BERTHS 97-109 [CHINA SHIPPING] CONTAINER TERMINAL PROJECT

Final Supplemental Environmental Impact Report (SEIR)

September 2019

Chapter 2 Response to Comments

Figure 1. Comparison of project-level NO_x emissions as represented in the 2008 EIR and 2017 DSEIR.⁴

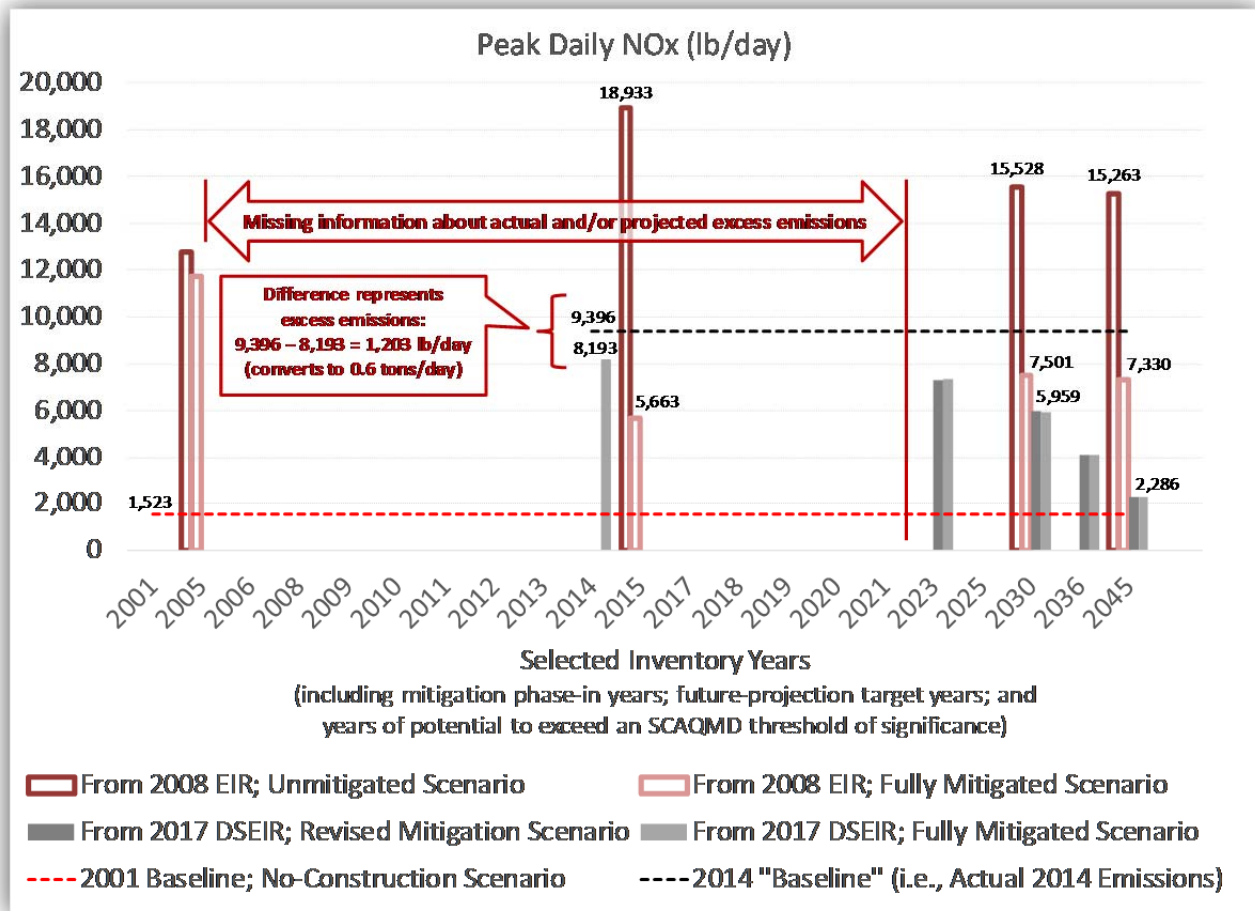
- An inconsistency was found in the 2008 EIR itself when comparing the approved mitigation scenario to the unmitigated scenario. For example, the 2010 NO_x emissions from cargo handling equipment associated with the approved mitigation scenario were actually higher than those for the unmitigated scenario (when clearly the opposite is expected). If the 2008 EIR is selected to be used as a reference to compare scenarios in the future, then further investigation and validation of the 2008 emissions estimates is warranted. (See discussion beginning on page 17 and Figure 12.)

Figure 3. Contributions of major source categories to project-level 2014 annual emissions of (a) NOx, (b) PM_{2.5}, (c) DPM emissions, and (d) PM₁₀ emissions.

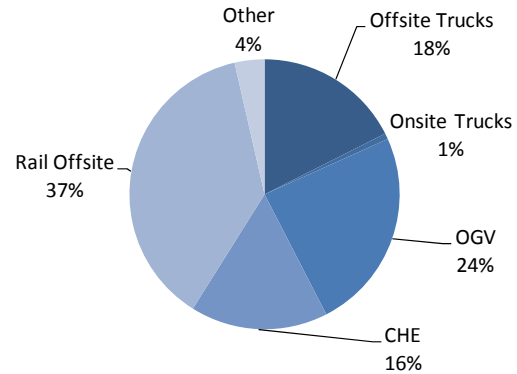
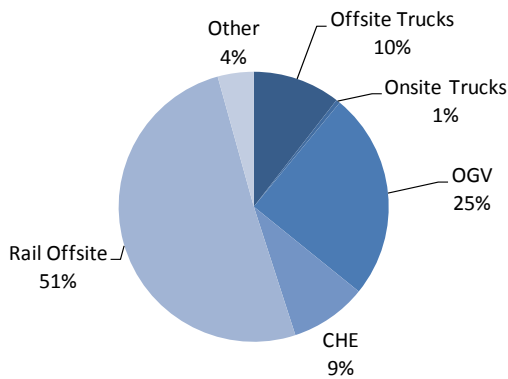
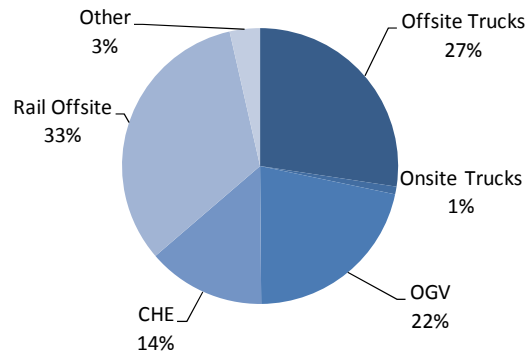
Selected mitigation measures affecting heavy-duty drayage trucks, hoteling of ocean-going vessels, top-pick cargo handlers, and rubber-tired gantry cranes (RTGs) were reviewed in greater detail. These emissions sources were selected for closer review because (a) they contribute significantly to the 2017 emission inventories (see **Figure 3**) and/or (b) the full implementation of approved mitigation measures would have yielded relatively large emissions benefits. The mitigation measures affecting these sources are re-stated briefly as follows (identifier numbers from the 2008 EIR appear in parenthesis).

30 The first part of this comment (Figure 3, page 7 and 8) refers to material presented in a
31 previous draft (the DSEIR). That document has been superseded by the Recirculated
32 DSEIR, in which additional analysis years have been added to the air quality analysis and
33 peak-day emissions have been updated; accordingly, this part of the comment is no
34 longer applicable.

Figure 4. Comparison of alternative estimates of annual PM emissions from on-site trucks.

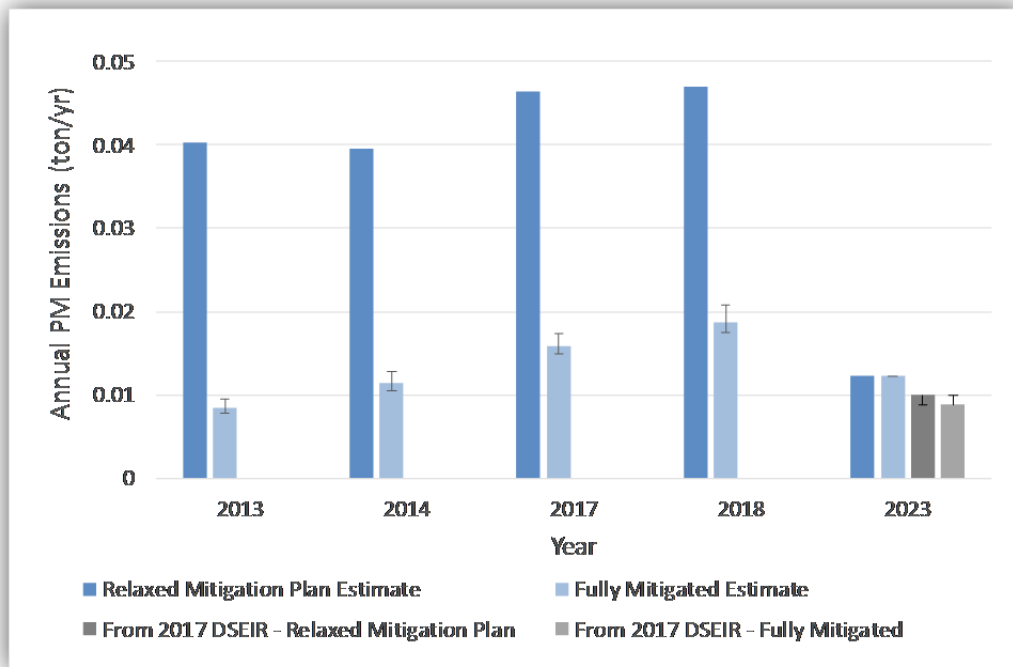
Figures 4 and 5 illustrate alternative estimates of project-level PM and NO_x emissions for heavy-duty trucks operating within the boundaries of the CS Container Terminal Project. Based on best available information, STI staff working under my direction prepared estimates of annual emissions for two scenarios⁵: (a) implementation of MMAQ-20 as approved (“Estimate - Fully Mitigated Plan” in the figures) and (b) implementation as proposed in the 2017 DSEIR (“Estimate - Relaxed Mitigation Plan” in the figures). These estimates cover several calendar years (2013, 2014, 2017, 2018, and 2023); and they are plotted alongside the analogous emissions estimates from the 2017 DSEIR for year 2023—i.e., the only comparable year covered in the 2017 DSEIR. **STI’s estimates show the excess emissions from heavy-duty trucks occurring, while the information from the 2017 DSEIR either omits (2013-2018) or even suggests no benefit from the approved mitigation plan in 2023.**⁶ Note that by ignoring years earlier than 2023, the 2017 DSEIR takes advantage of an EMFAC-projected conversion of the vehicle fleet in 2023 to modern emissions standards—after which time, diesel and LNG trucks are expected to emit PM at similar rates. In other words, federal or statewide regulations are expected to yield a large drop in PM emissions from diesel vehicles in 2023, regardless of which mitigation scenario is in effect at the CS Container Terminal. However, the lack of NO_x benefits projected for 2023 in the 2017 DSEIR is unsupported. LNG vehicles are known to emit NO_x at a much reduced rate compared to diesel vehicles. However, the **NO_x emission factors used in the 2017 DSEIR for heavy-duty trucks are contrary to published literature.** Not only are the emission factors for diesel-fueled trucks set to be equal to those for LNG-fueled trucks in the 2017 DSEIR, but the NO_x emission factors for heavy-duty trucks increase from 2023 to 2045 (see **Figure 6**). Both of these patterns are contrary to published literature.⁷

Figure 11. Comparison of various NO_x emissions scenarios for cargo handling equipment as represented in the 2008 EIR and 2017 DSEIR.⁴

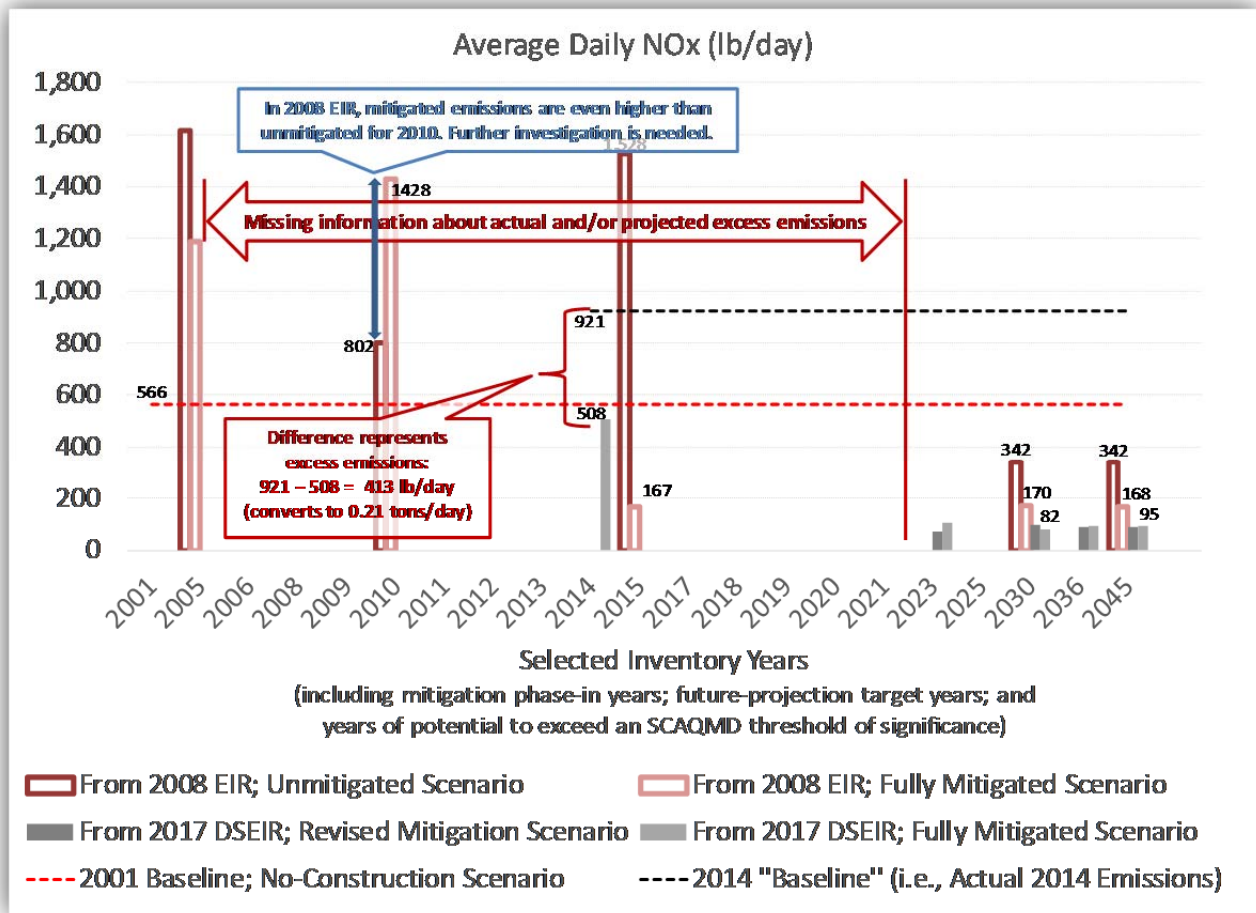
- Figures 11 and 12 illustrate project-level, peak-day NO_x and PM_{2.5} emissions for cargo-handling equipment. An inconsistency issue was found in the 2008 EIR for analysis year 2010 where emissions for the approved mitigation scenario are greater than the emissions for the unmitigated scenario. If emissions from the 2008 EIR are used as a basis for comparison, estimates for these two scenarios need to be verified.
